Re: Public comment on Conditional Use Permit #CU-12-04.

**BEFORE THE PLANNING COMMISSION OF THE  
CITY OF TILLAMOOK  
PRELIMINARY FINDINGS AND CONCLUSIONS  
CONDITIONAL USE PERMIT #CU-12-04  
T1S R9W Section 30, Tax lot 800;  
T1S R9W Section 30BC, Tax lot 200;  
T1S R9W Section 30BD, Tax lots 600, 700;  
T1S R10W Section 25AC, Tax lots 300, 400, 4500, 4501, 4600;  
T1S R10W Section 25AD, Tax lots 200, 401, 501, 502, 600, 700, 701.**

**REQUEST:** To construct a new 115-kilovolt (kV) transmission line between  
the Bonneville Power Administration's (BPA) Tillamook  
Substation located to the east of the City of Tillamook on Oregon  
Route 6 and a proposed PUD substation (Oceanside Substation)  
near the community of Oceanside in Tillamook County.  
Approximately 1.1 miles of the approximately 7.0-mile  
transmission line route are within the jurisdiction of the City of  
Tillamook, and the remaining 5.9 miles are within the jurisdiction  
of Tillamook County. Therefore, the Applicant requests approval  
of a conditional use permit (CUP) from the City of Tillamook for  
the construction of the 1.1-mile portion of the transmission line  
that crosses the City of Tillamook. A separat

**FIGURE 2**  
**Proposed Project,**  
**City of Tillamook**  
 CUP Application  
 Tillamook-Oceanside Transmission Line  
 Tillamook PUD

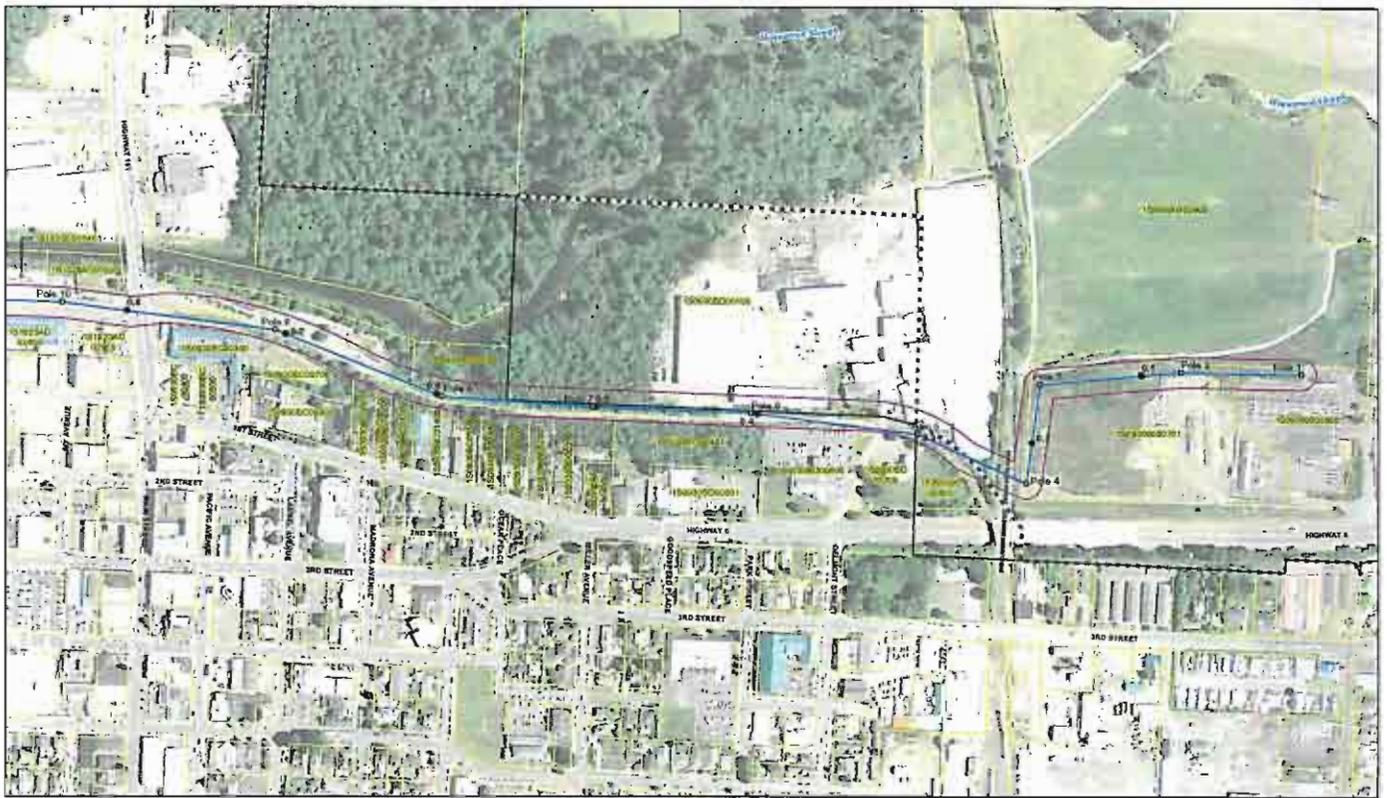
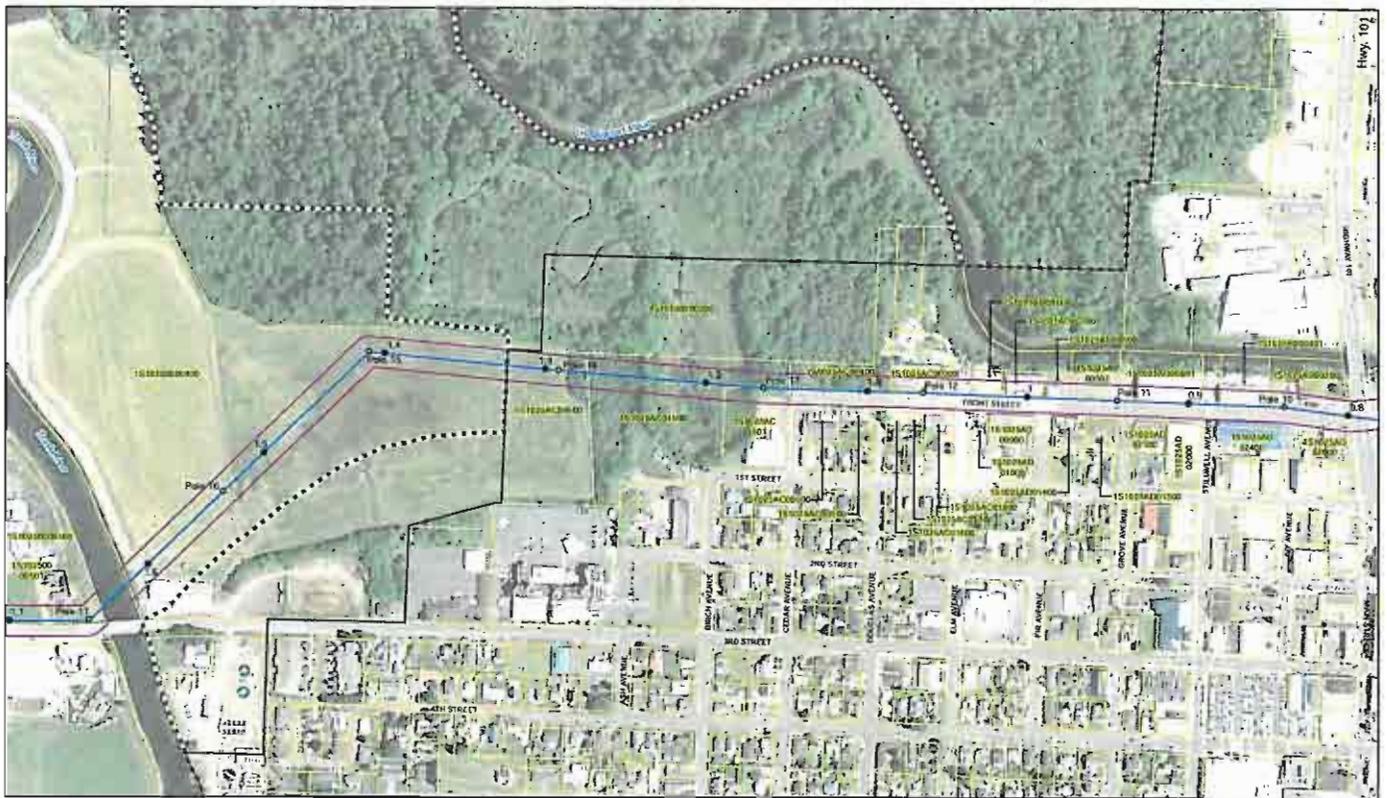
Attached you will find the update that we spoke about on Figure 2. The easement is now accurate at 50 feet on both sides of the transmission line as it heads west from 101, like we spoke about on the phone. I put 10 copies in the mail for you, and they should arrive on Friday.
